**BEFORE THE INDEPENDENT HEARING COMMISSIONERS
IN CHRISTCHURCH**

IN THE MATTER of the hearing of submissions on Plan Change 14
(Housing and Business Choice) to the Christchurch
District Plan

JOINT STATEMENT OF TRANSPORT EXPERTS

26 September 2023

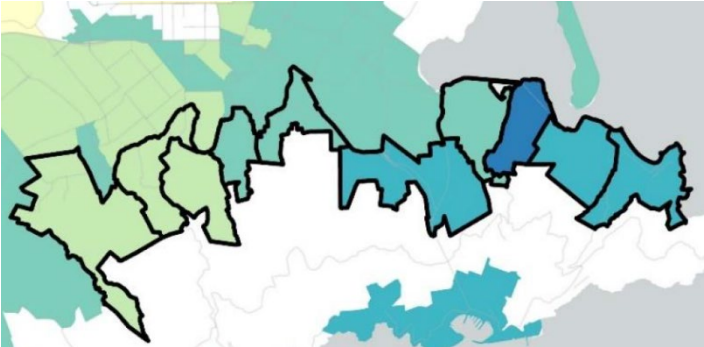
Appropriateness of medium density residential development in locations serviced by lower-tier bus routes (paragraphs 6.13, 6.15, 6.16, 6.17 & 6.21 of Mr Smith’s evidence)	Growth will result in increased use of these public transport routes and enable service improvements to be justified in future.	<p>DS considers that residential growth will result in increased use of these lower-tier public transport routes, and make it more likely that improvements will occur in future to service this demand. Notes that there are plans to improve many of the routes servicing these areas.</p> <p>CM agrees, but considers that the same level of residential growth in areas better serviced by public</p>

<p>transport will have an even greater impact on increasing patronage and enabling future improvements, and therefore positive impacts on the transport network.</p>
<p>Application of LPTAAQM to various residential hill suburbs (Table One of Mr Smith’s evidence, and associated maps in Attachment One)</p>	<p>Table 1 shows that some residential hill suburbs have relatively high public transport uptake (e.g. Sumner, Heathcote Valley, Huntsbury, Redcliffs).</p> <p>It also shows some have relatively high active mode share (walking and cycling).</p> 	<p>DS: PT and active mode share on hillside suburbs is similar to other suburbs</p> <p>DS Attachment 2 shows southern hillside suburbs are within easy cycle / PT access of CBD</p> <p>CM notes that some of these are not under the QM (e.g. portions of Cashmere East and West, Huntsbury). Others are under the QM but in the areas CM agrees are well-serviced by public transport and should be removed from the QM (e.g. Sumner, Redcliffs).</p>
